# City of Austin Residential Permit Application Master Comment Report

**Original Submittal Date:** March 10, 2014  
**Application Expiration:** September 6, 2014  
**Comment-report Sent Date:** April 10, 2014  
**Comment-report #:** 0

**Property:** 1303 E 2ND ST  
**Case #:** 2014-023459 PR  
**Case Manager:** Juan Camou  
**Manager Contact:** Juan.Camou@austintexas.gov

FIGURE R602.10.1.1  
BRACED WALL LINES

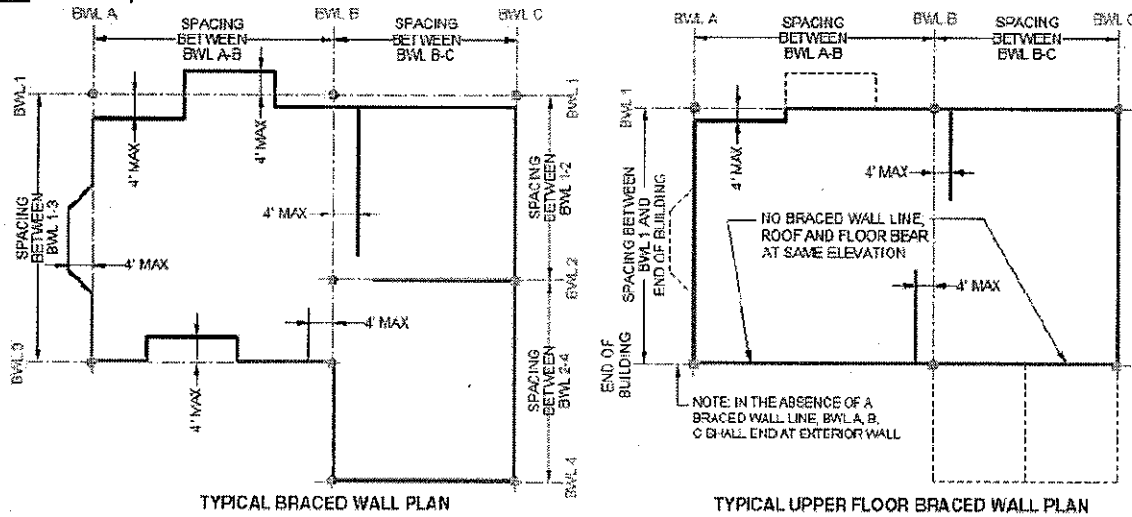
5. Roof structural plans required for new carport roof.
6. Submit brace wall plan stamped by engineer showing compliance with the currently adopted IRC. The plan shall **clearly indicate the braced wall lines** (Refer to IRC Figure R602.10.1.1 for sample showing BWL), the braced wall methods used, locations of the methods used at new and modified wall, and reference applicable details already provided. *General notes regarding continuous sheathing or references to code sections will not be accepted.*
